Addendum 1

DATE	11/19/2024
PROJECT NAME	IU BI065 OPTOMETRY SCHOOL LAR LAB HUMIDIFIER REPLACEMENT
INTROBA PROJECT #	2035.0012888
IU PROJECT #	20231438
DISTRIBUTION	Owner
ADDENDUM CONSIST OF	(6) 8.5 X 11 PAGES AND (1) 30X42 FULL-SIZE SHEETS

DRAWING TITLE: MECHANICAL DEMOLITION AND NEW WORK PLAN

DRAWING NO: M110

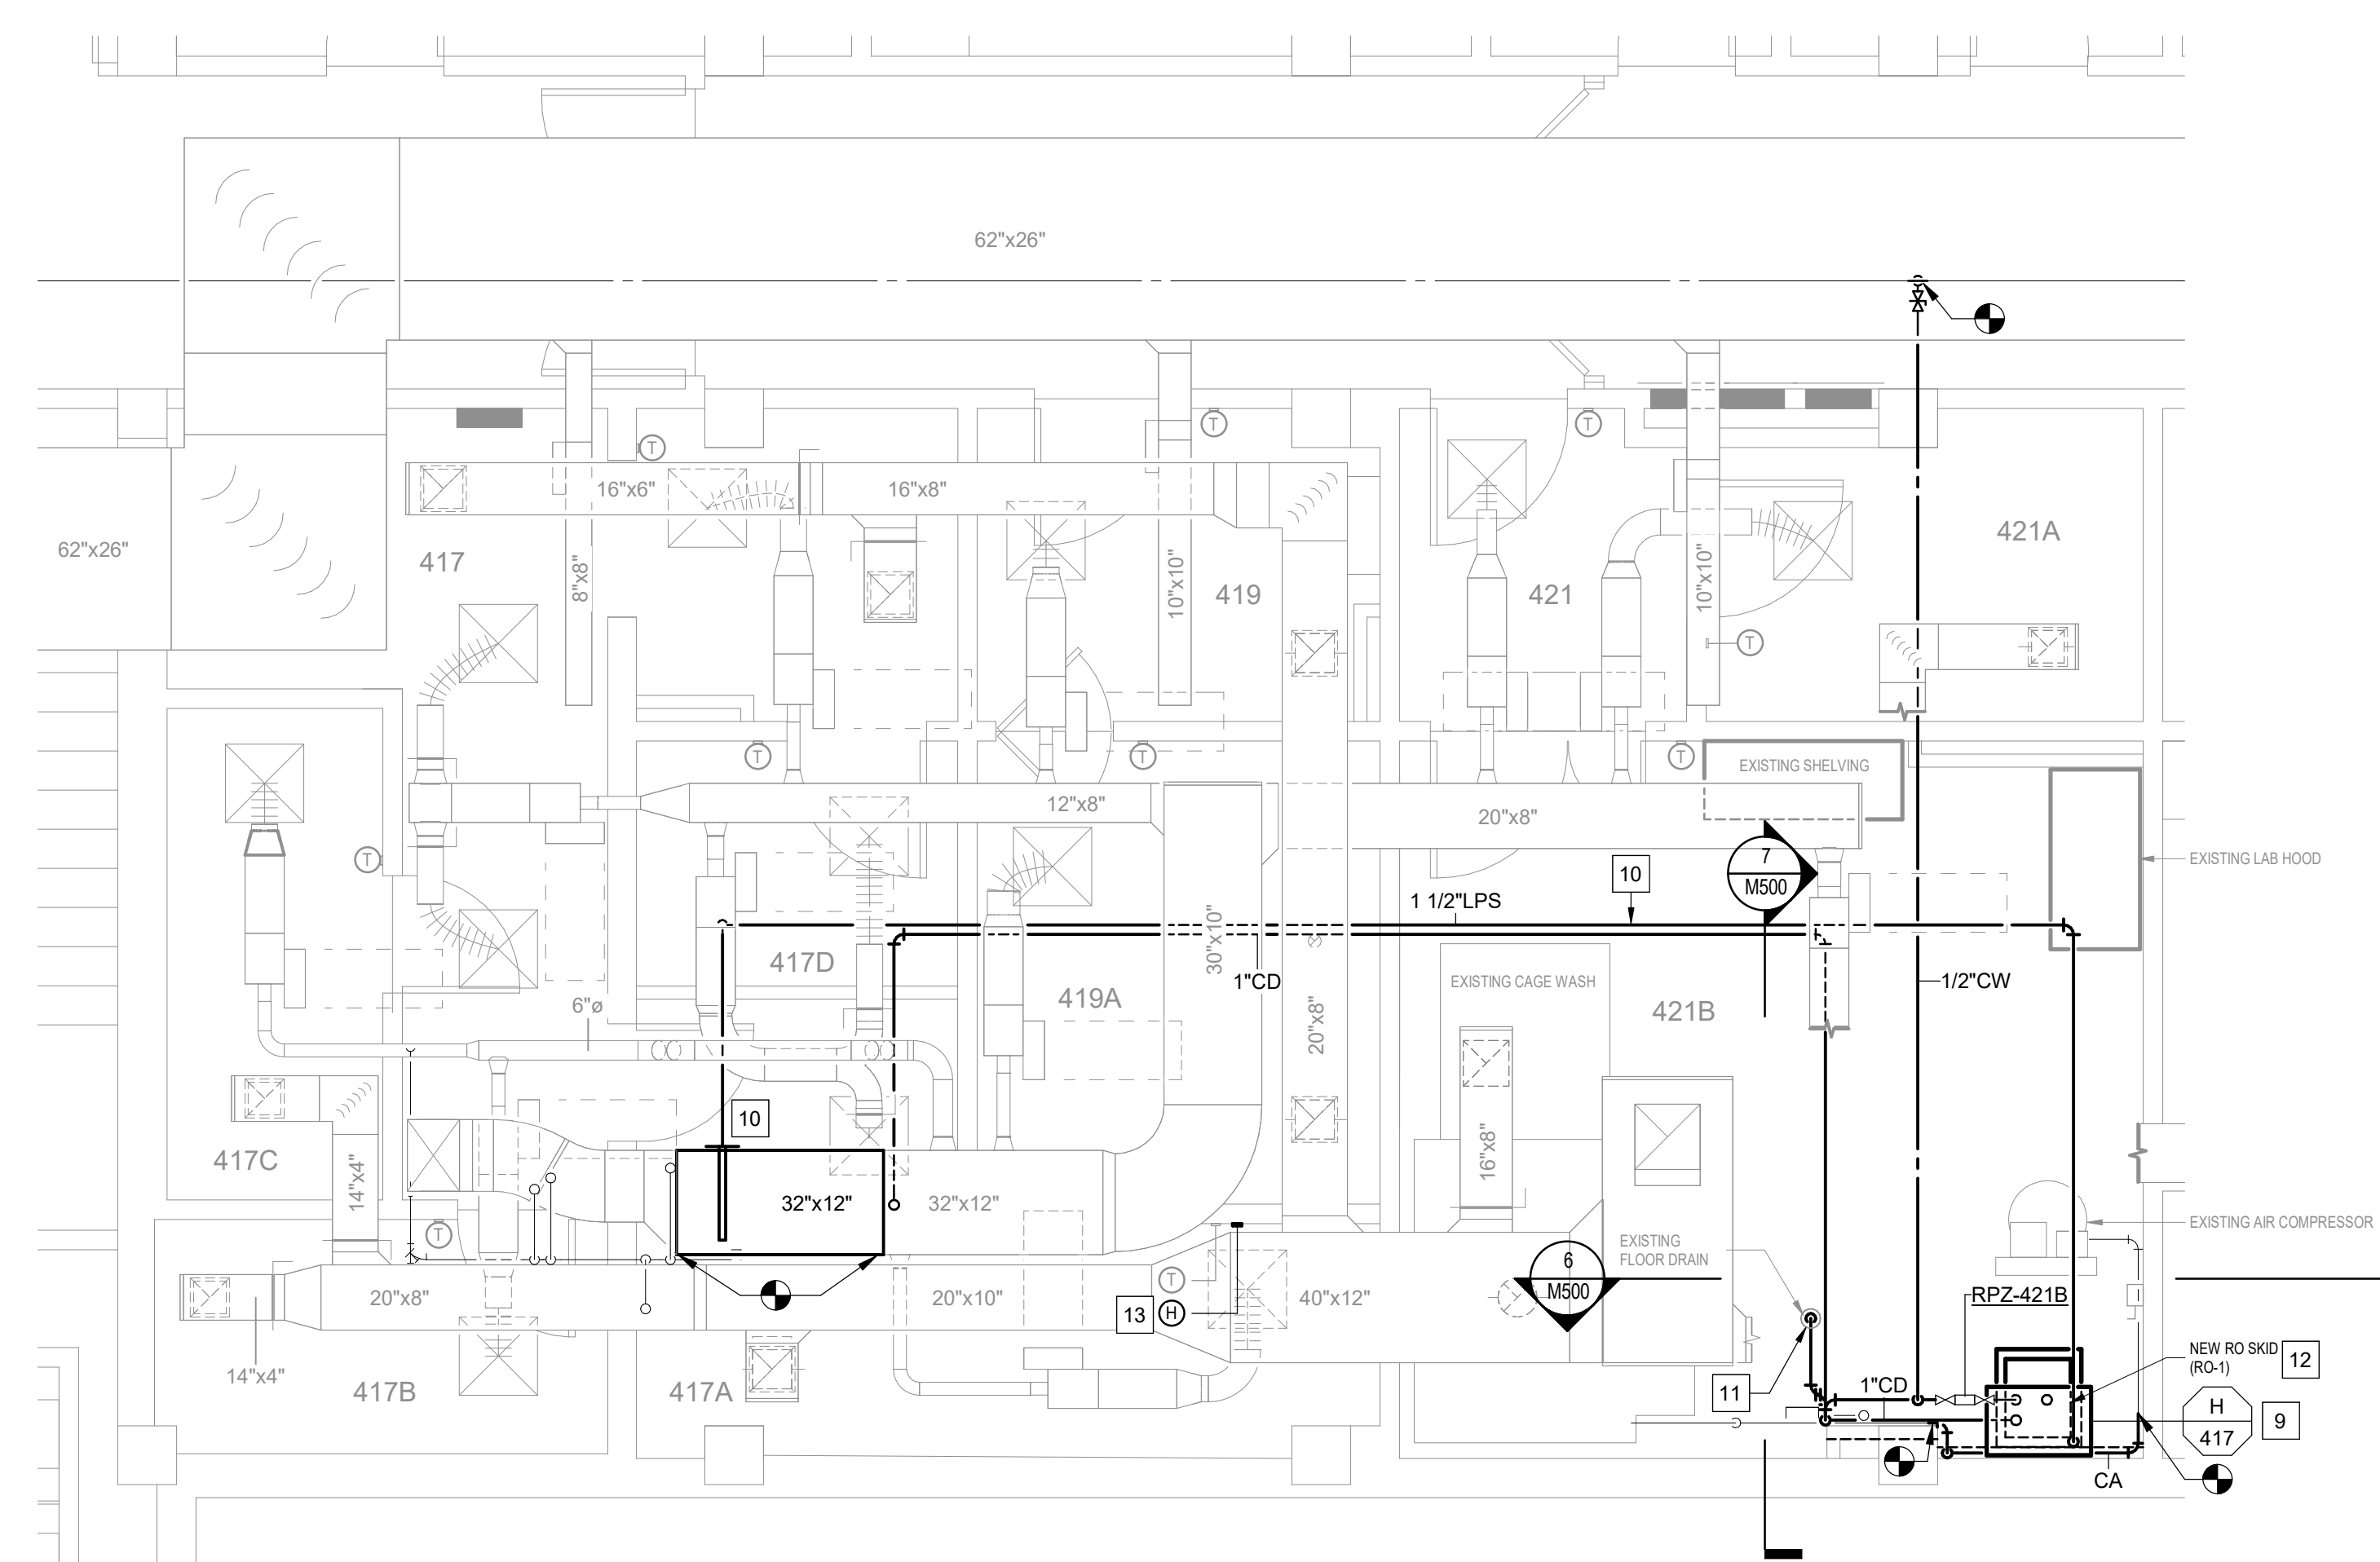
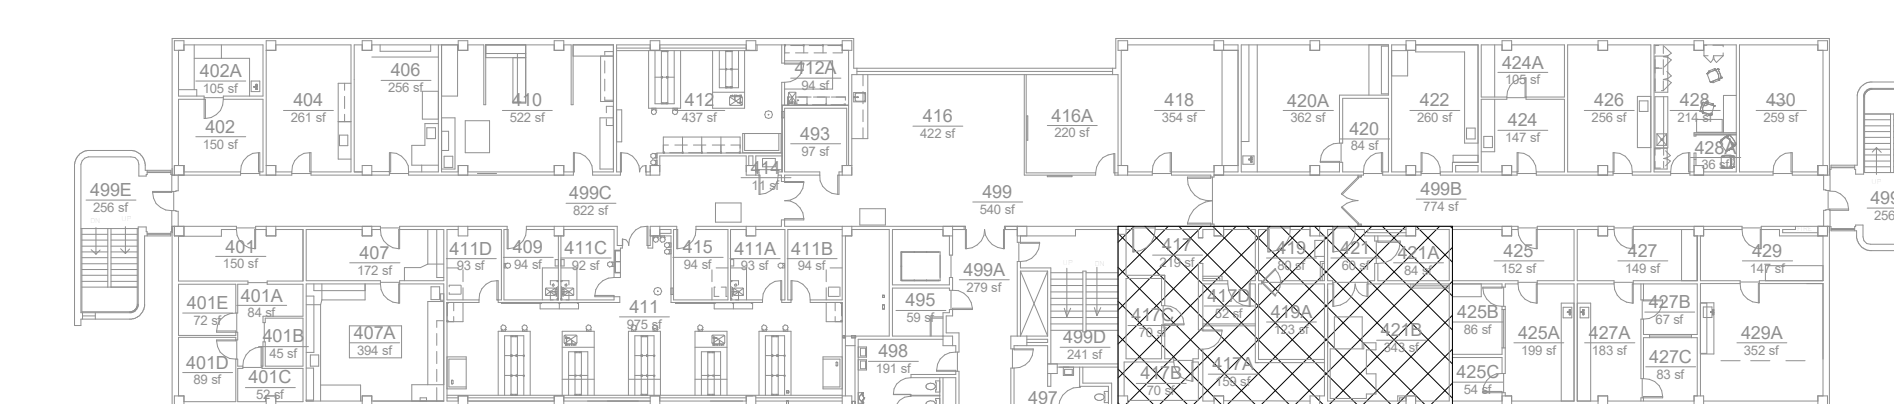
1. M110 – MECHANICAL SCHEDULES:
 - a. Sheet Keynotes. Updated keynote #1 to address removal of existing steam generator condensate drain piping and the remaining existing condensate drain piping from other equipment and floor drain shall be existing to remain.
 - b. Sheet Keynotes. Updated keynote #12 to include the RO skid basis of design as well as additional RO skid information.

- REMOVE EXISTING STEAM GENERATOR, ASSOCIATED STEAM PIPING, MAKEUP WATER PIPING, CONDENSATE DRAIN PIPING, CONTROLS, AND ACCESSORIES COMPLETELY. PATCH AND PAINT WALLS AS REQUIRED. CAP CONDENSATE DRAIN PIPING AT PIPING CONNECTION. EXISTING CONDENSATE DRAIN PIPING CONNECTIONS TO OTHER EQUIPMENT AND FLOOR DRAIN SHALL BE EXISTING TO REMAIN.

- ROUTE CONDENSATE DRAIN PIPING TO DRAKE-KOOLER (PROVIDED BY HUMIDIFIER MANUFACTURER) AND DISCHARGE CONDENSATE DRAIN PIPING TO FLOOR DRAIN.
- NEW RO SKID FOR STEAM GENERATOR. BASIS OF DESIGN DRISTEEM MODEL HYDROTURBO RO 200 SERIES. RO SYSTEM HAS PREFILTER RATING 5 MICRONS, 120W/190HZ, 5.5 FLA, PAINTED STEEL WITH RUBBER BLADDER STORAGE TANK MATERIAL, 1/2" SYSTEM INLET, 3/8" SYSTEM OUTLET. OVERALL DIMENSIONS OF 34"x20"x30", AND OPERATING WEIGHT 180 LBS AS REPRESENTED BY THE HILL COMPANY (THE HILL COMPANY INC., 317-856-5266). MOUNTED ON FLOOR ON EQUIPMENT PAD. ROUTE NEW DOMESTIC COLD WATER PIPING FROM EXISTING DOMESTIC COLD WATER LINE TO RO SKID AND CONNECT RO SKID ONTO NEW WALL MOUNTED STEAM GENERATOR. INSTALL NEW REDUCED PRESSURE BACKFLOW PREVENTER AND ROUTE DRAIN TO EXISTING FLOOR DRAIN. REFER TO SHEET M500 FOR ELEVATION VIEWS OF EQUIPMENT.
